## Summary of changed for 1512Y

Photo 1 (Before)

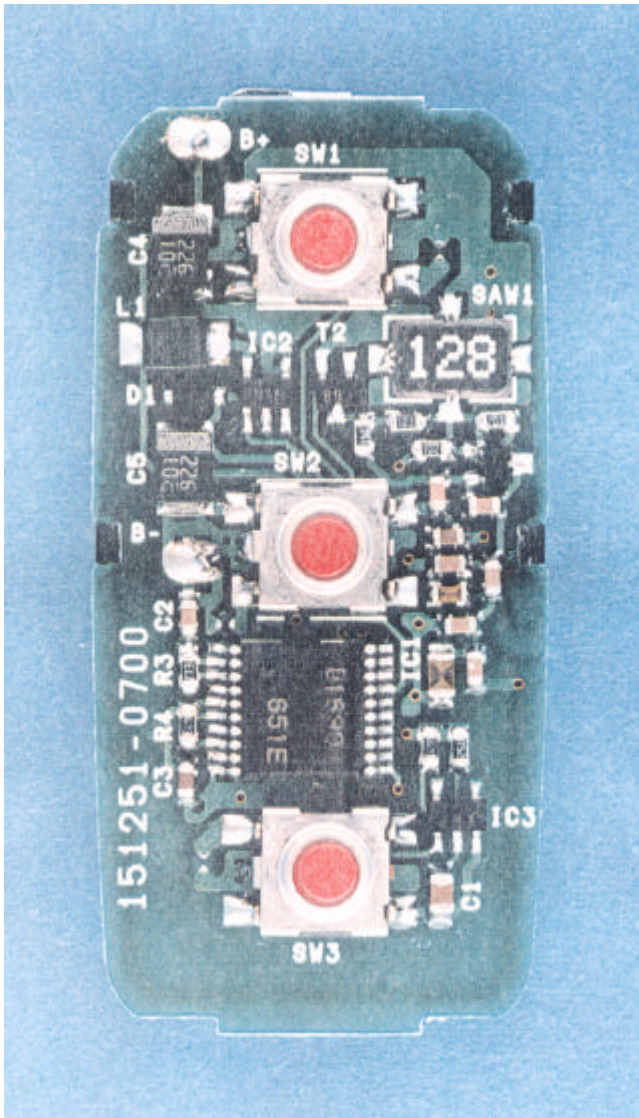
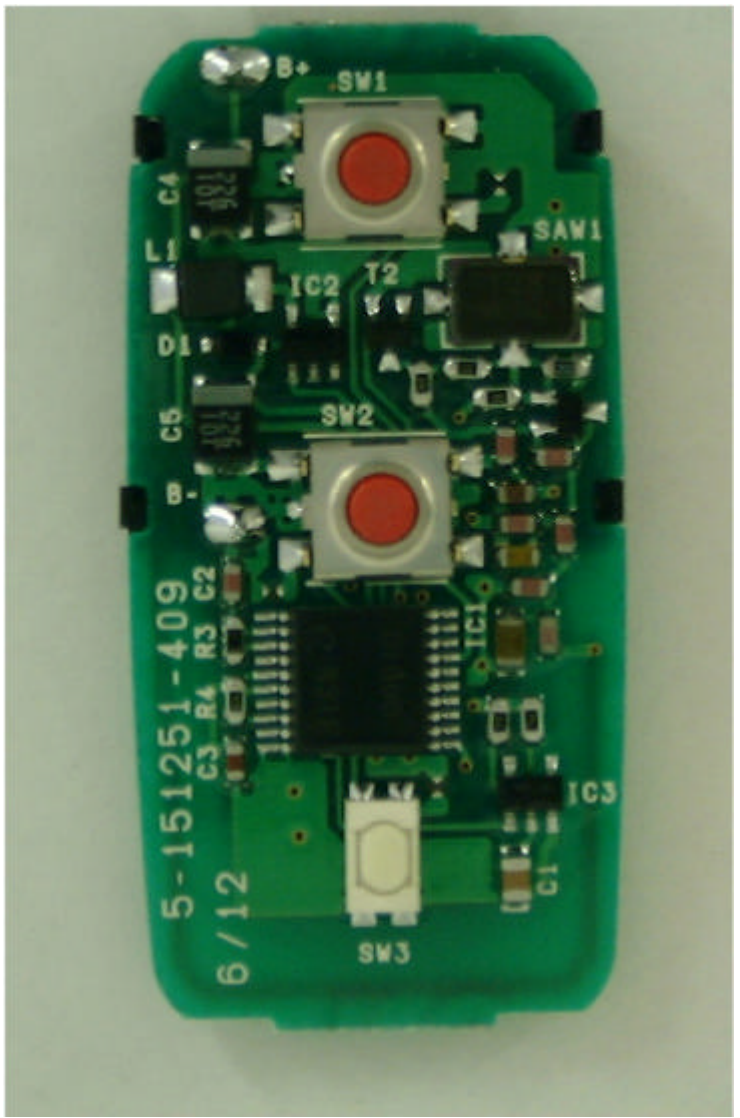
## 2. Changed Component

The following parts are changed.

Item	Part name	Before	After
C2	Capacitor	18pF	24pF
C6	Capacitor	5pF	2-8pF
C7	Capacitor	1pF	0.5-3pF
C8	Capacitor	8pF	5-11pF
C9	Capacitor	1pF	0.5-3pF
C11	Capacitor	18pF	13-24pF
C12	Capacitor	8pF	5-11pF
L2	Inductor	27nH	15-47nH
L3	Inductor	39nH	22-68nH
R3	Resistor	27k	22k
R6	Resistor	20k	15-27k
R7	Resistor	12k	9.1-16k
R8	Resistor	390	300-510
SW	Switch	Photo1	Photo2
